TITLE XD10 Software V1.01.16		NUMBER RN-E990	REV	PAGE 1 of 5
DEPARTMENT Engineering	CREATED BY: F. Pflaum	EFFECTIVE DATE Sept. 09, 2004	APPROVED BY: L. Brown

This software update for the XD10 is to be installed in all XD10 units. The update provides some new features, and corrects some problems in the previous version, as detailed below. This update **MUST** be installed to enable future XD10 operation with enhanced audio discs.

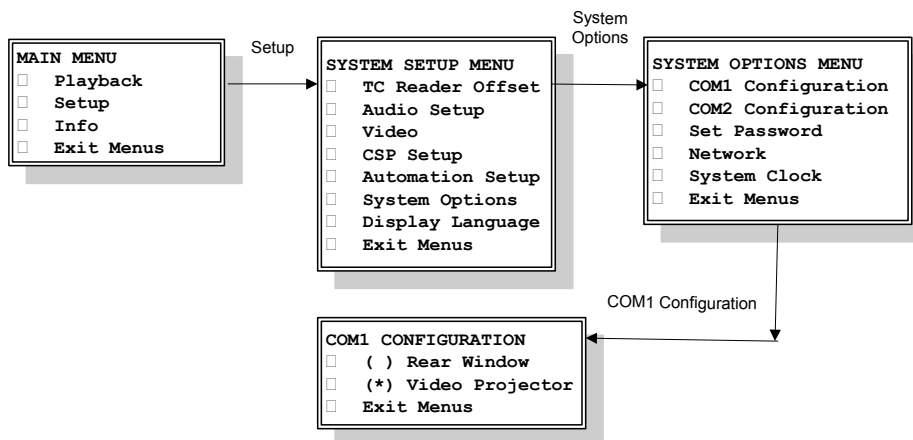
Added a setup screen to use the COM1 port for either Rear Window (default) or video projector control. See notes below for video projector control mode.

The menu is under **SETUP → System Options → COM1 Configuration** as shown below:

6. Video Stop Output

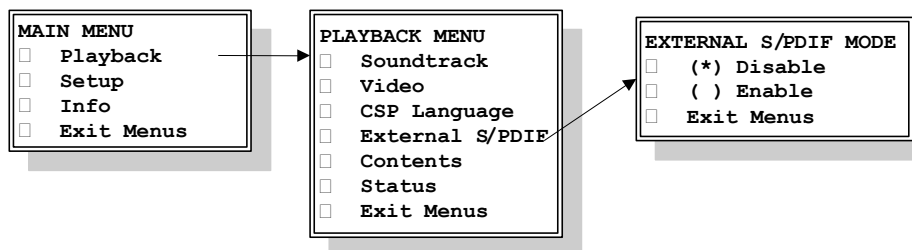
Fixed the “Video Stop” output signal. When the video playback terminates, there will now be a negative pulse on the corresponding output pin when that pin is assigned to be the “Video Stop” function. (This is set in the menu: System Setup → Automation Setup → I/O Control → Pin Definitions → Output.)
